Salboy
Back Turner Street
External Materials + Planning Updates

Proposed changes to Non Material Amendment Approved Application

The purpose of this report is to document the proposed design amendments to the Back Turner St - original planning approval Reference 126638/FO/2020 26.06.20, subsequently updated with the approved NMA Application Reference: 128851/MMC/2020

2.4 Elevation Comparison Soap Street Block A

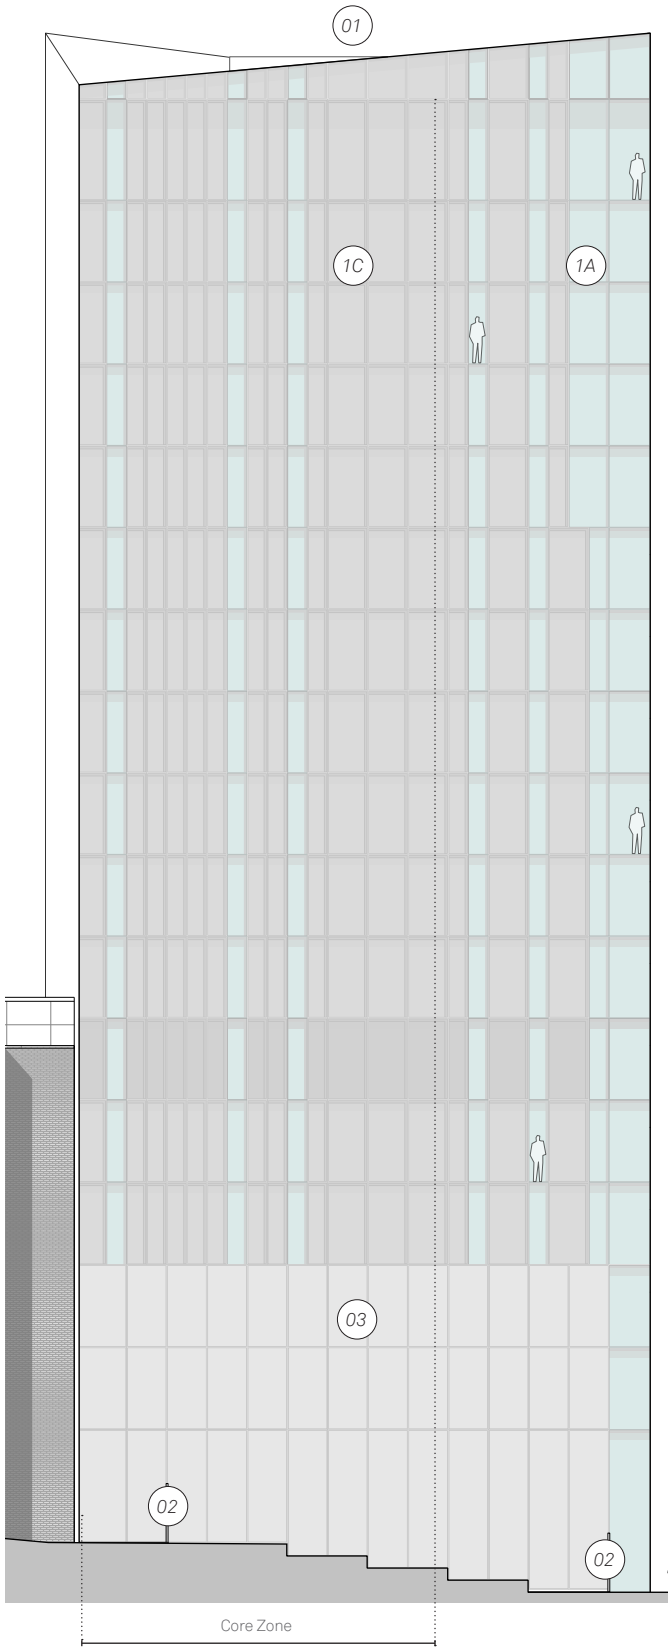
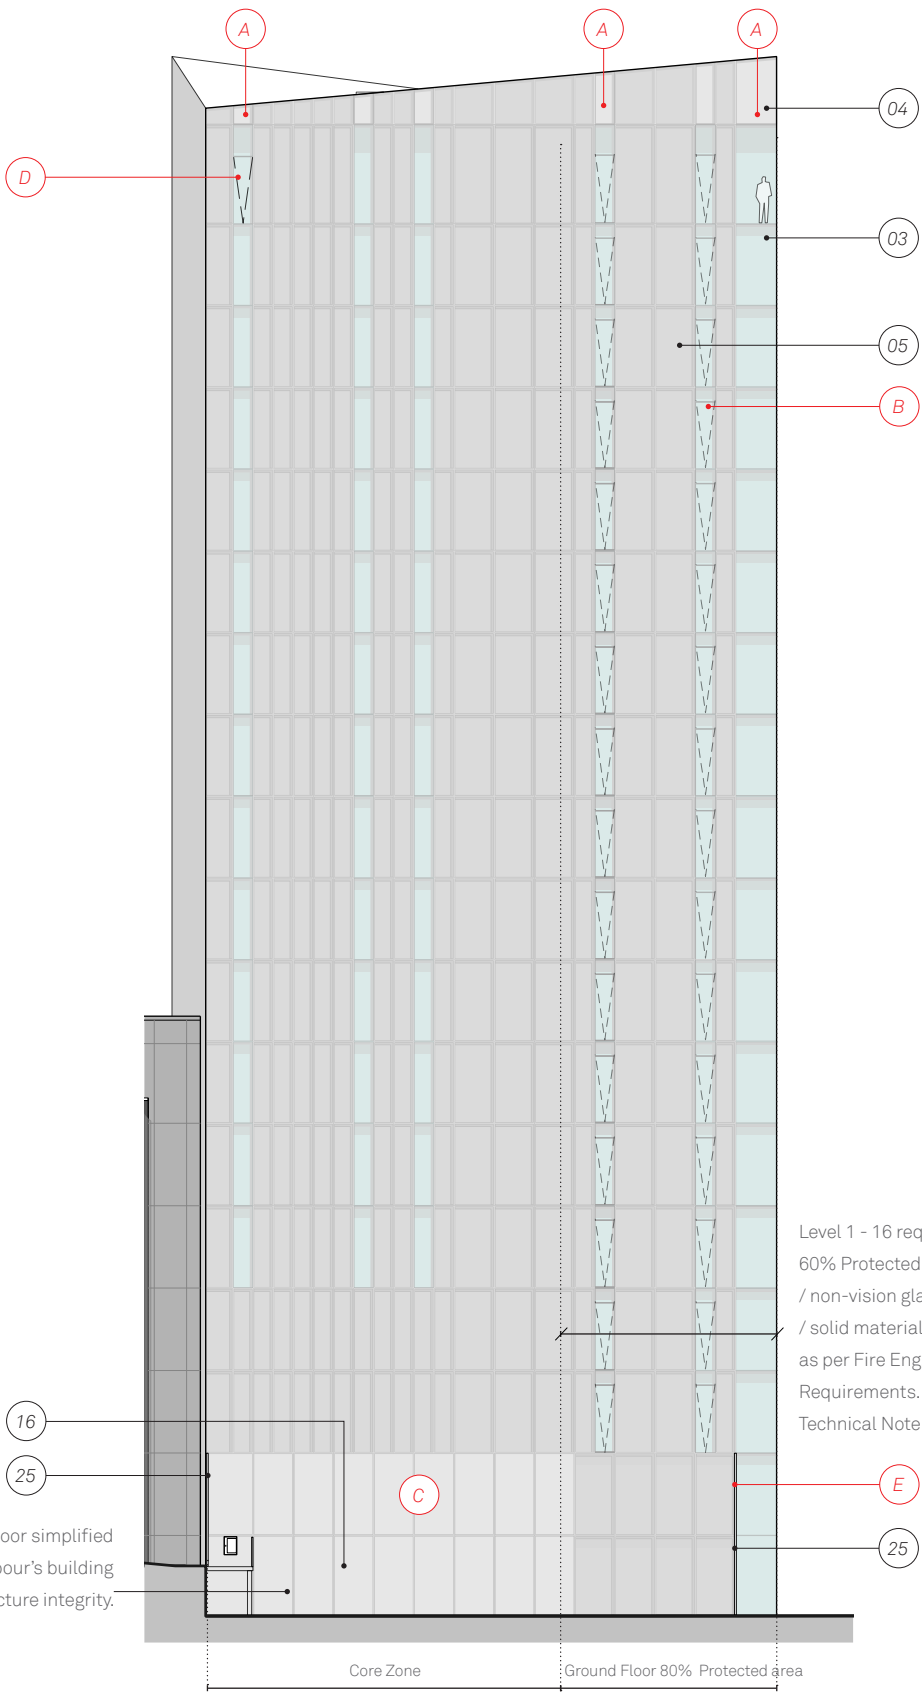
- Summary of changes proposed
- obscured glazing to the crown of the building to mask plant
 - additional AOV added to the tower stair core
 - tower glazing modules adjusted to accommodate 1500mm wide AOV to meet fire requirements
 - extent of metal cladding reduced to express more the aesthetic of the tower to Soap St. and Shudehill

- Planning Material change Key
- A - Glazing to roof overrun to be 30% translucent
 - B - The façade treatment beyond the core had to be revised to meet fire regulations. This meant more solid elements and the introduction of AOV's. See Technical Note
 - C - Area of Metal cladding reduced
 - D - Additional AOV added to stair core
 - E - Screen height increased
